Sydney Metro Martin Place

North Tower Base Building Changes

SSD/ MOD drawings & FC2 Comparison

Rev #02 – 26/10/21

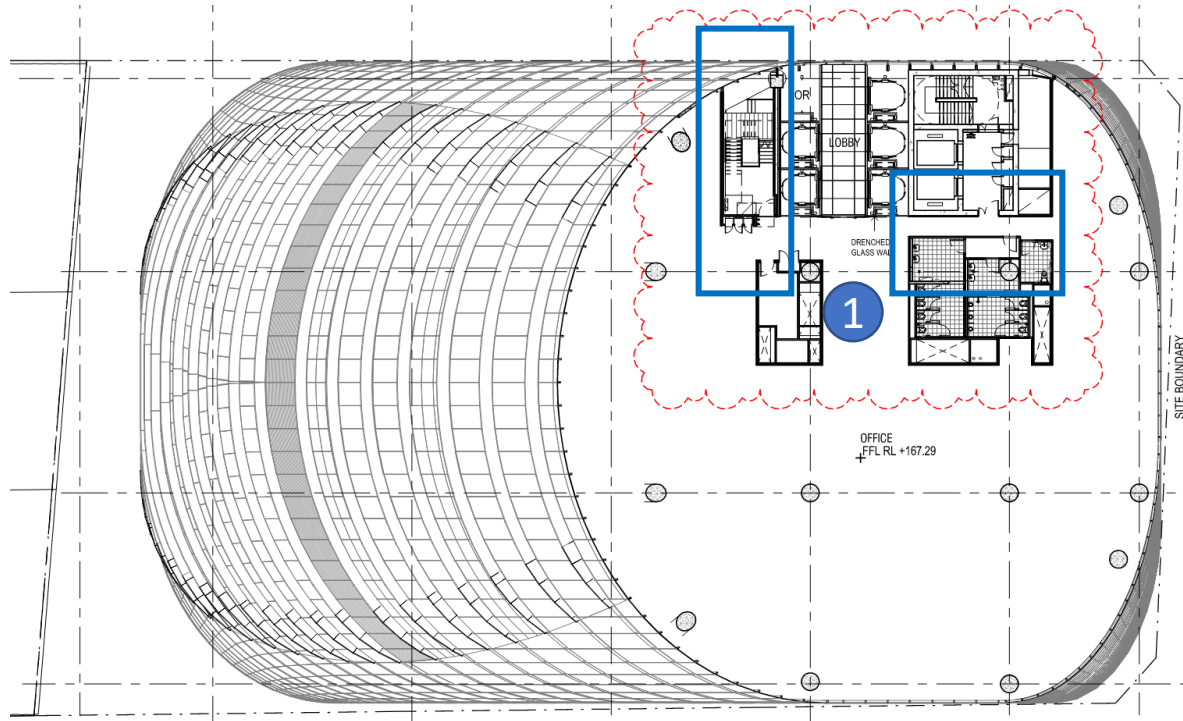
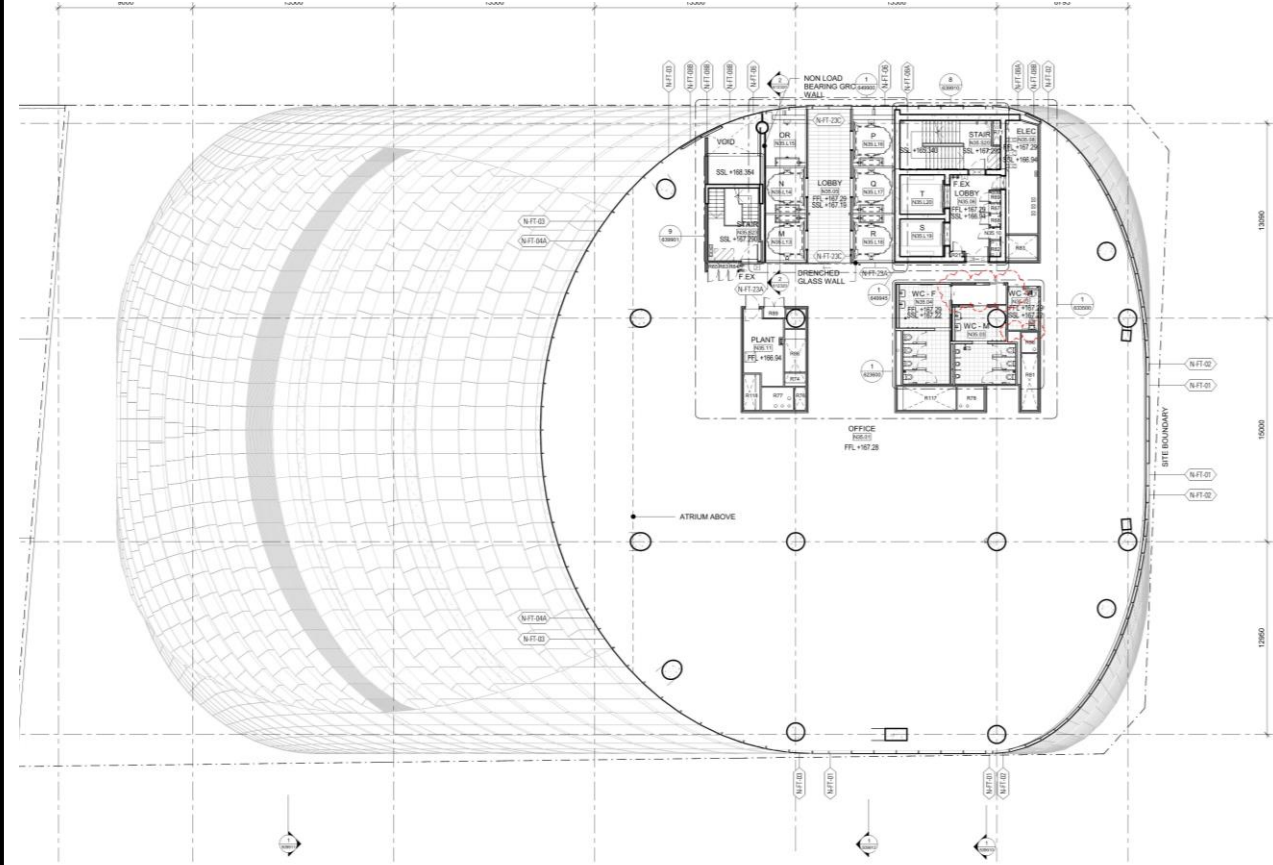
1.BOH revised

Level 36 Plan

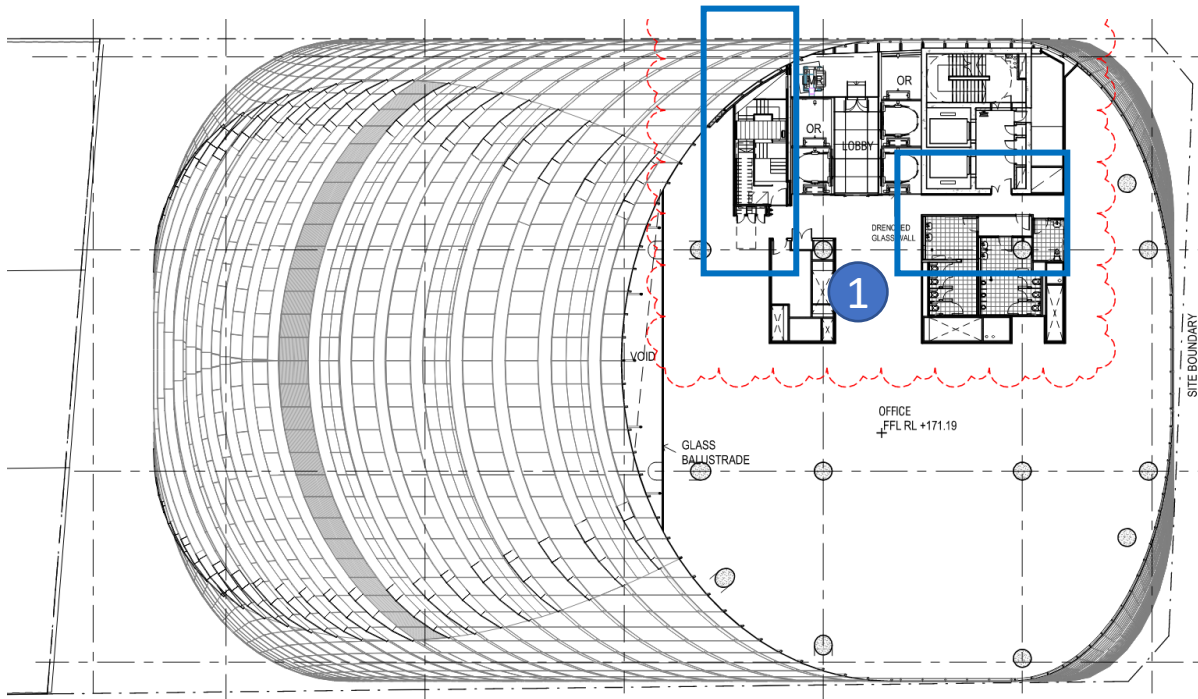
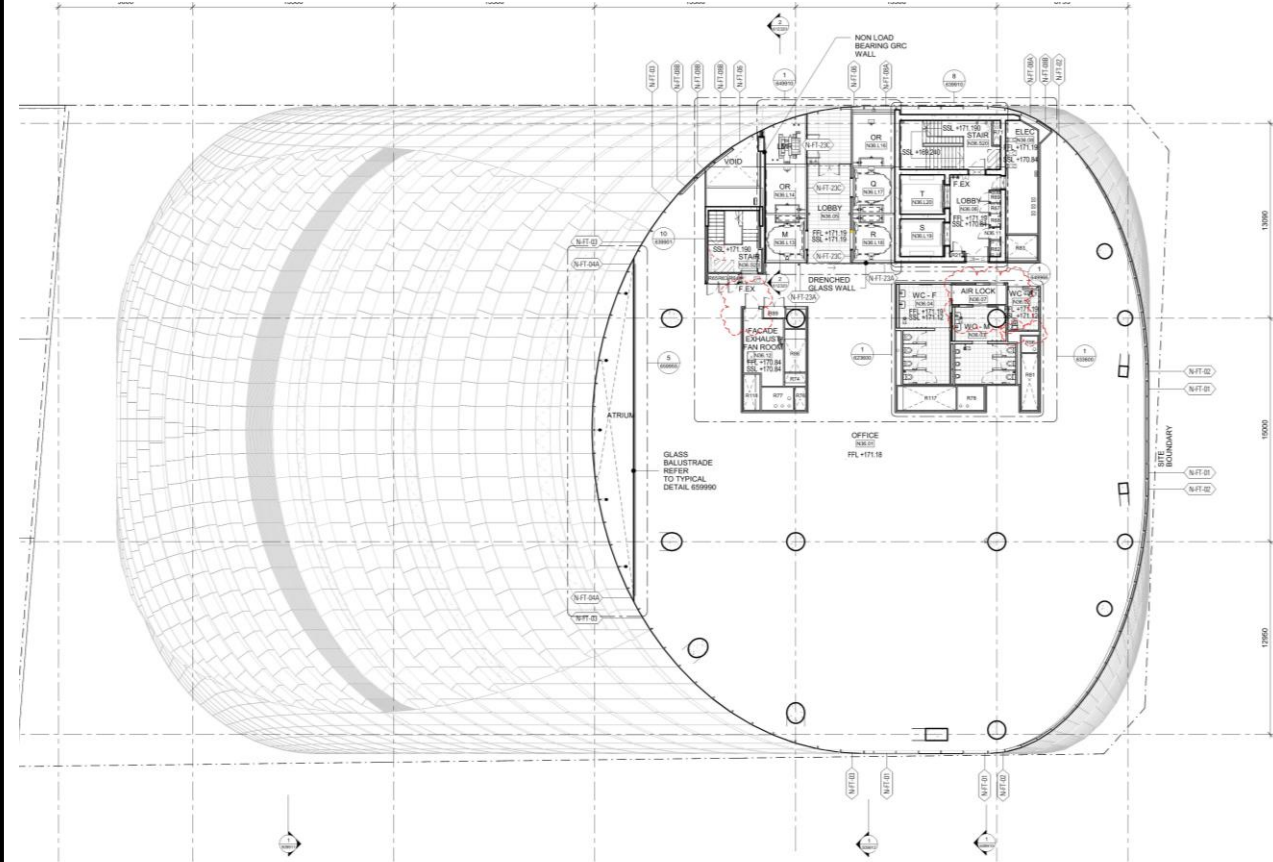
1. BOH revised

Level 37 Plan

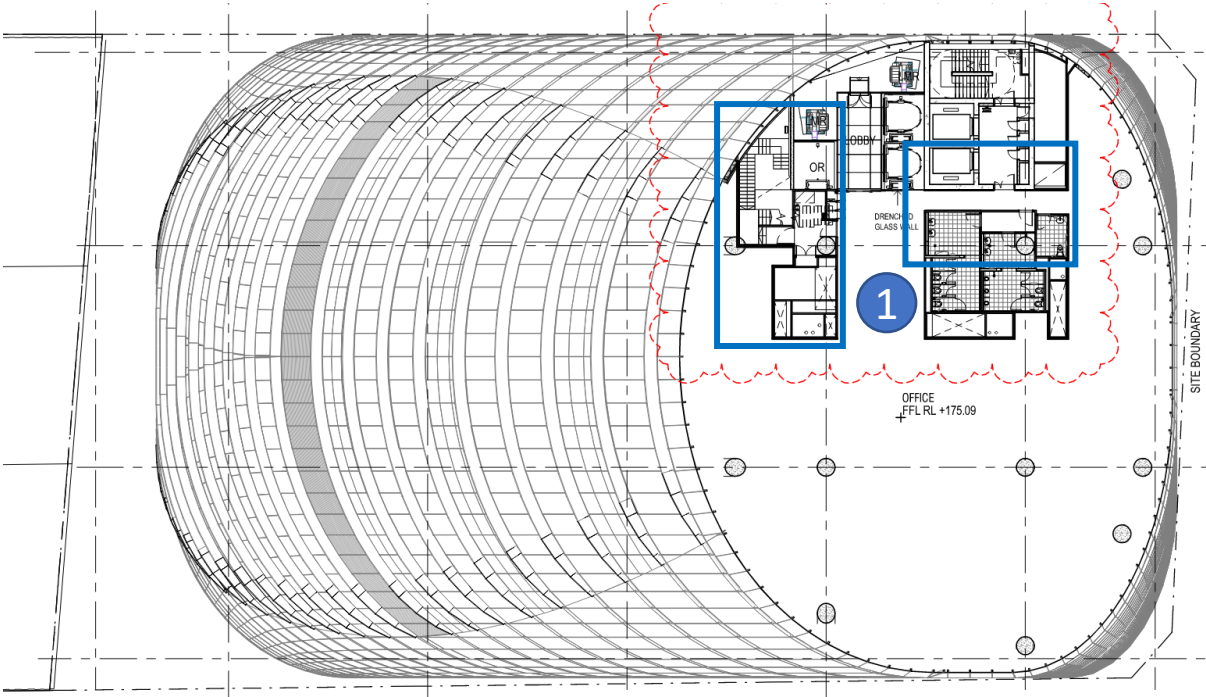
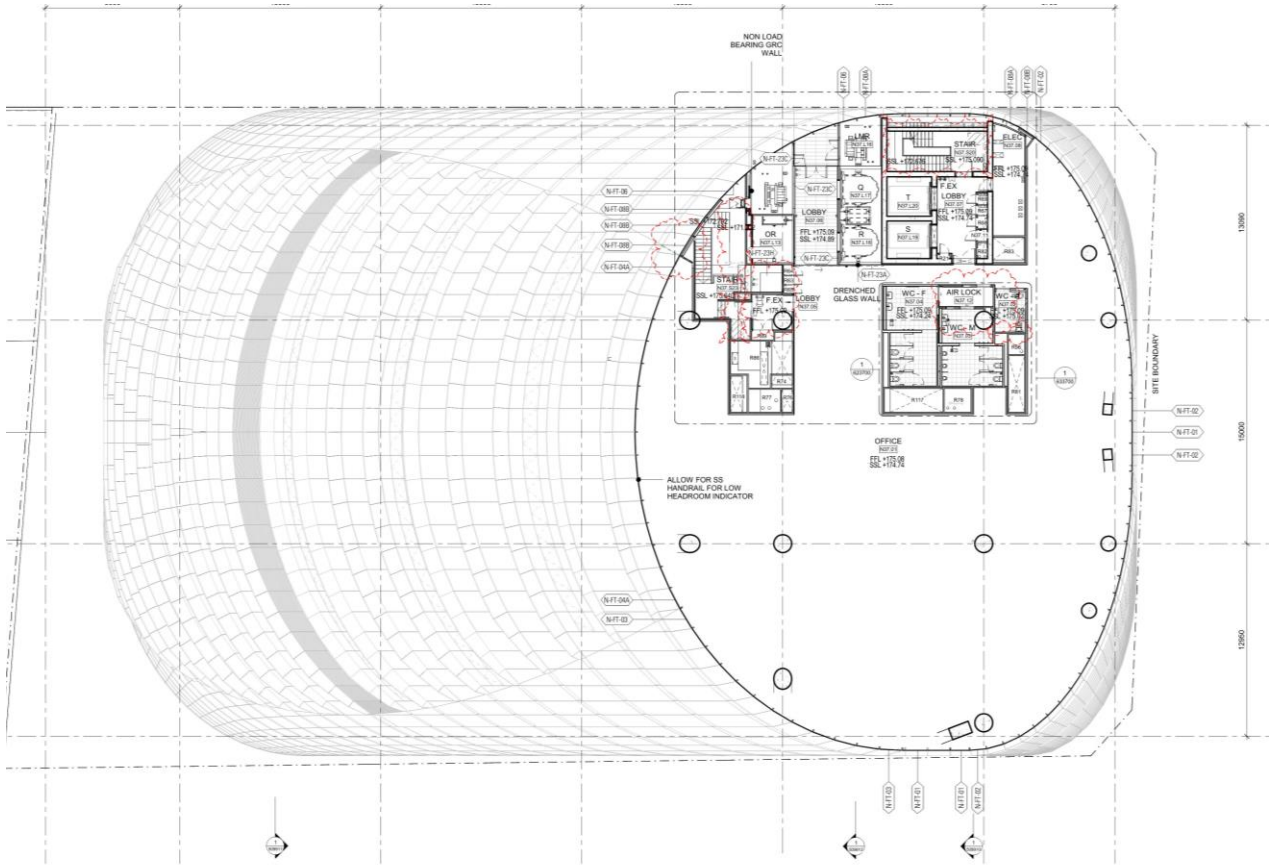
1.BOH revised

Lower Roof Plan

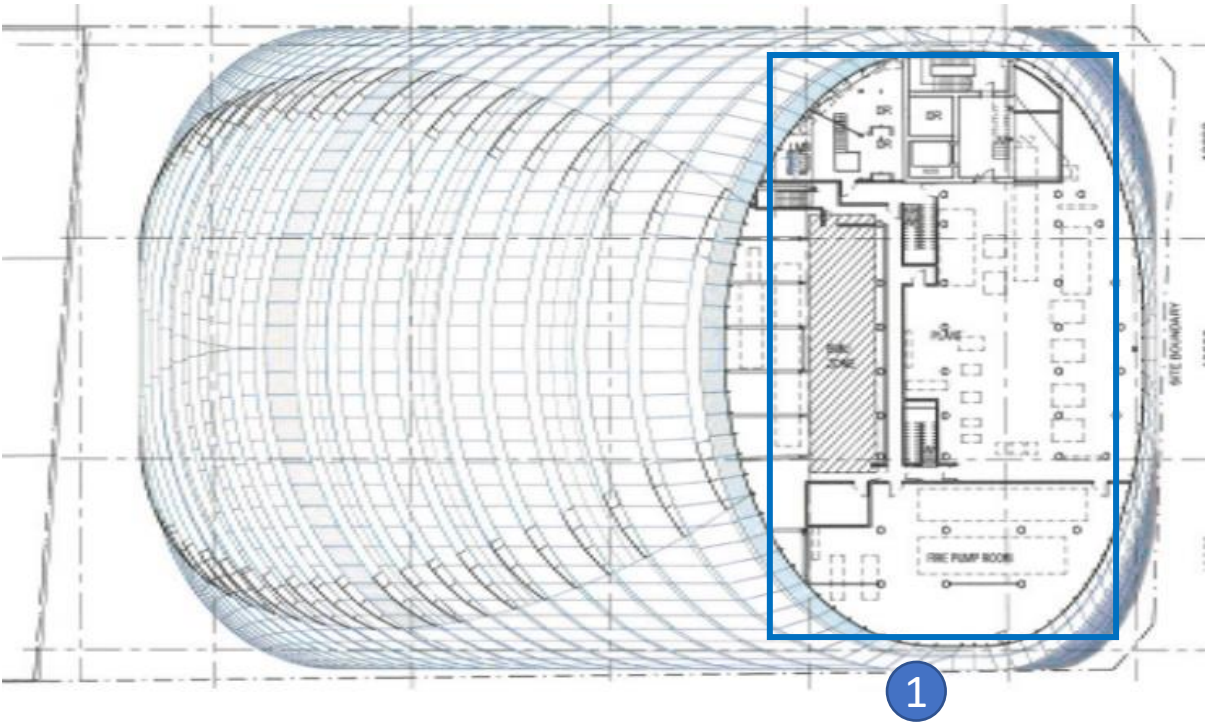
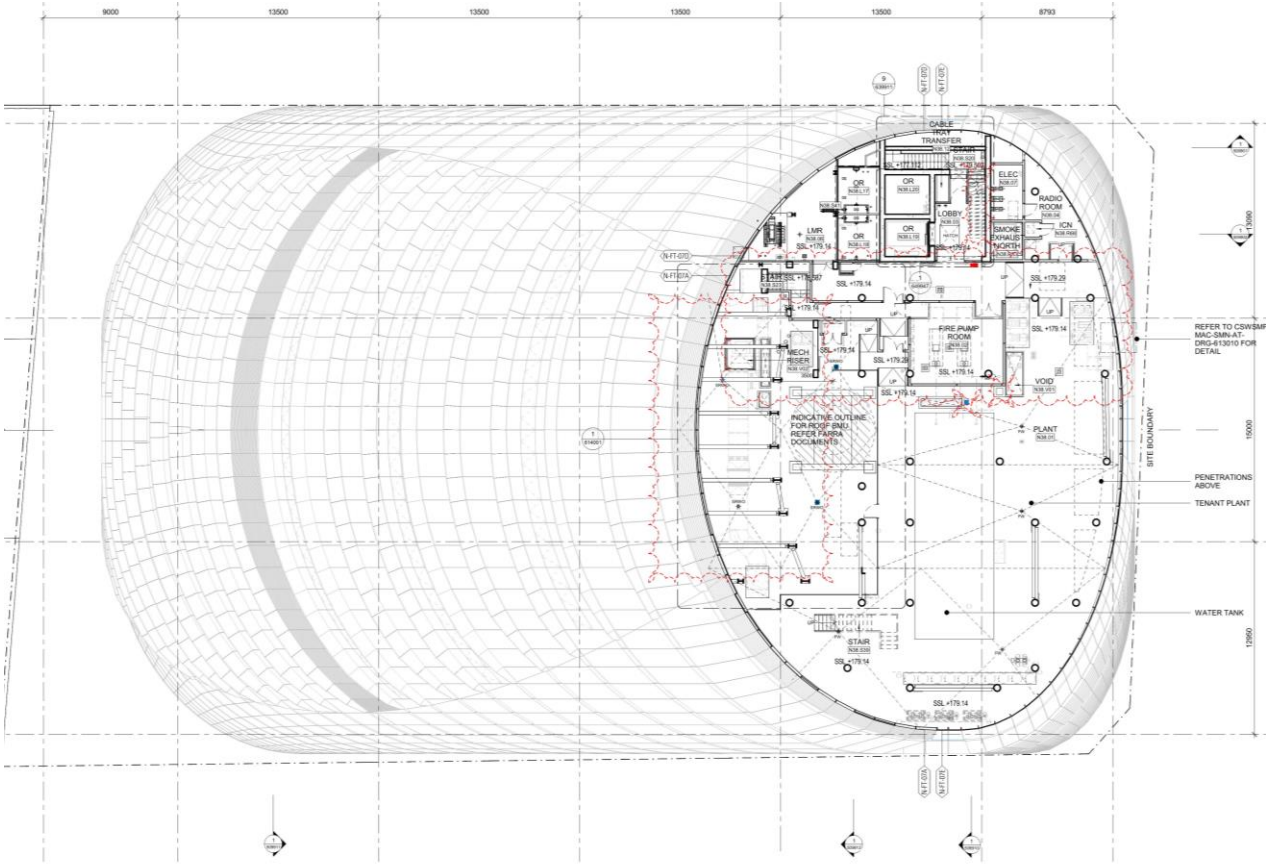
1.Plant layout revised

Upper Roof Plan

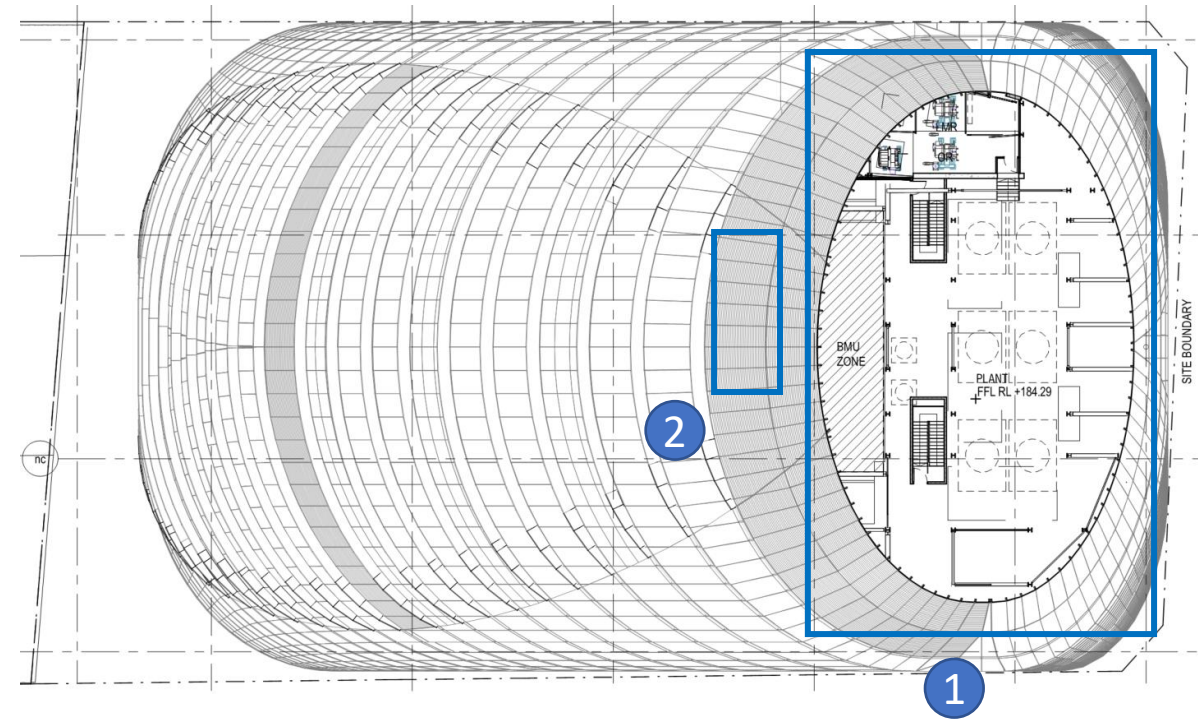
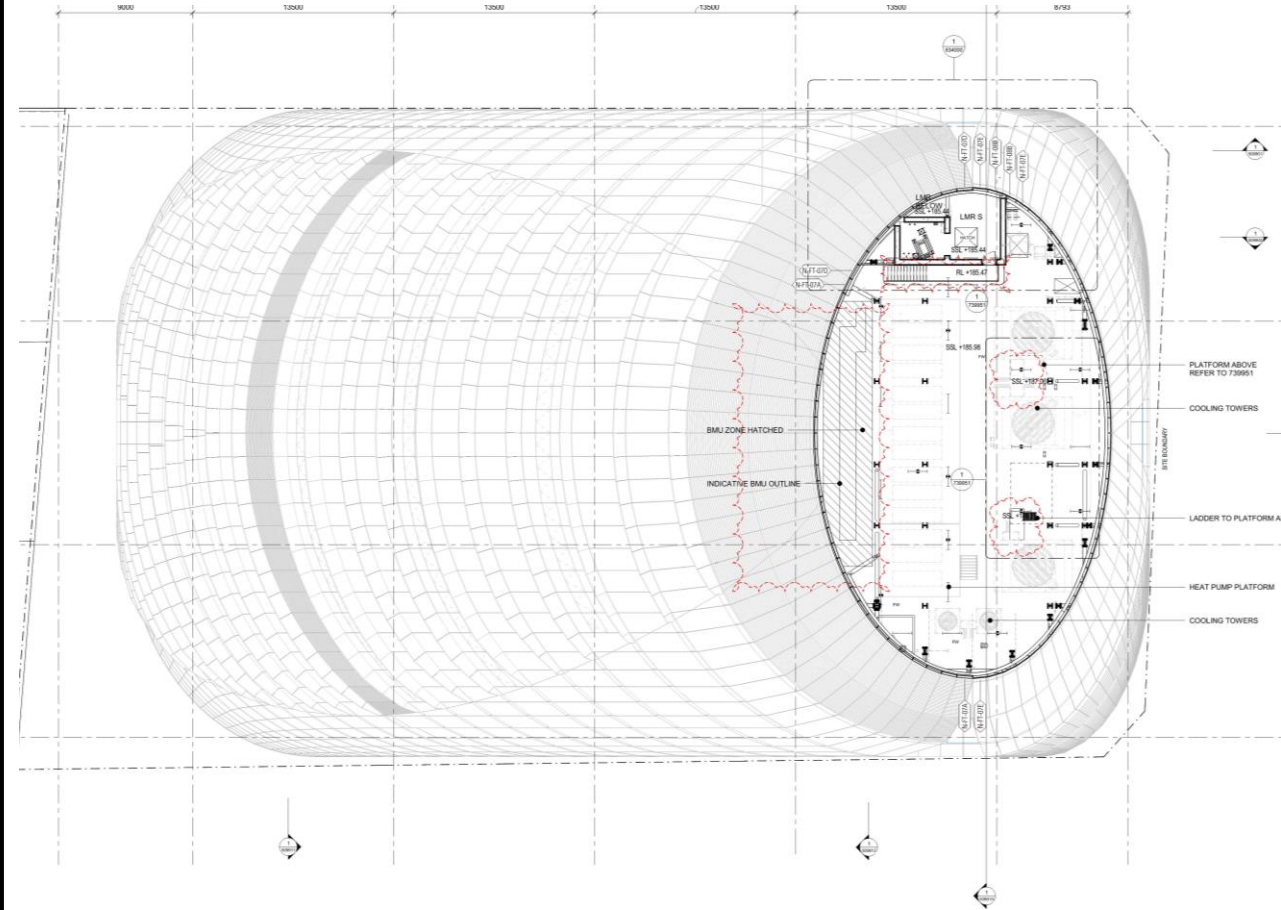
- 1.Plant layout revised
- 2.BMU hatch reduced

East Elevation

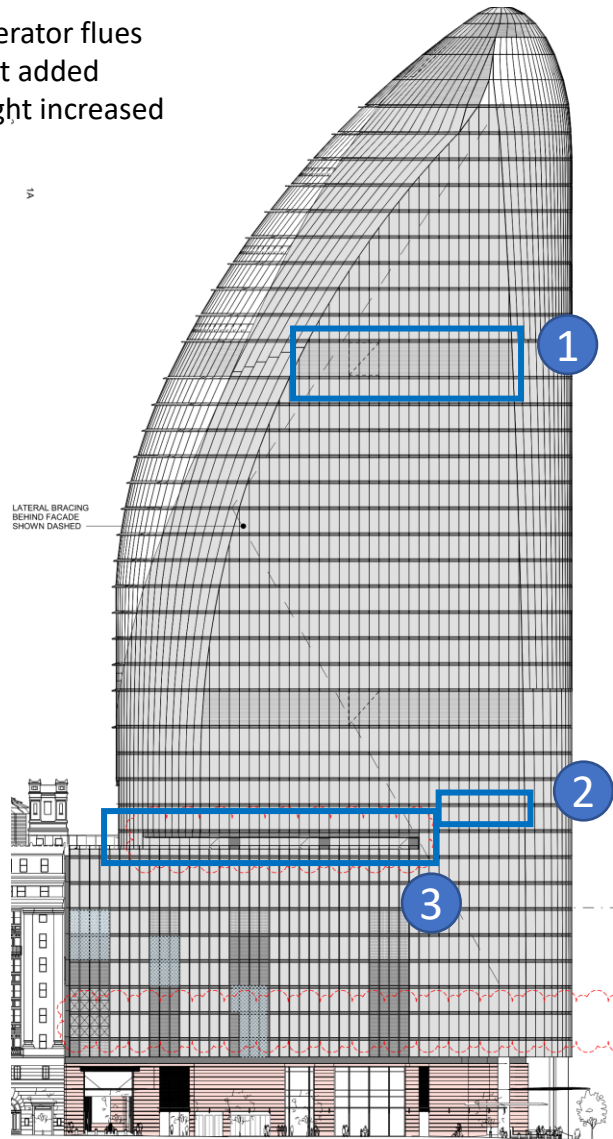
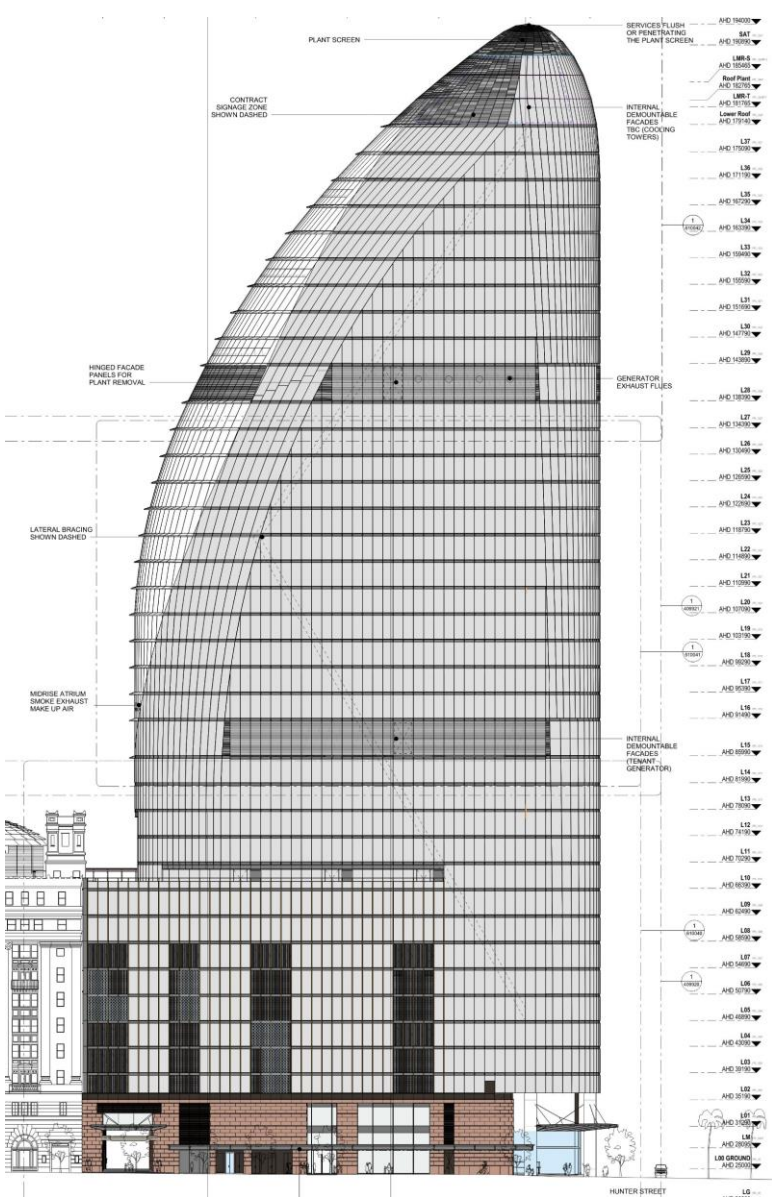
- 1.Additional generator flues
- 2.Kitchen exhaust added
- 3.Balustrade height increased
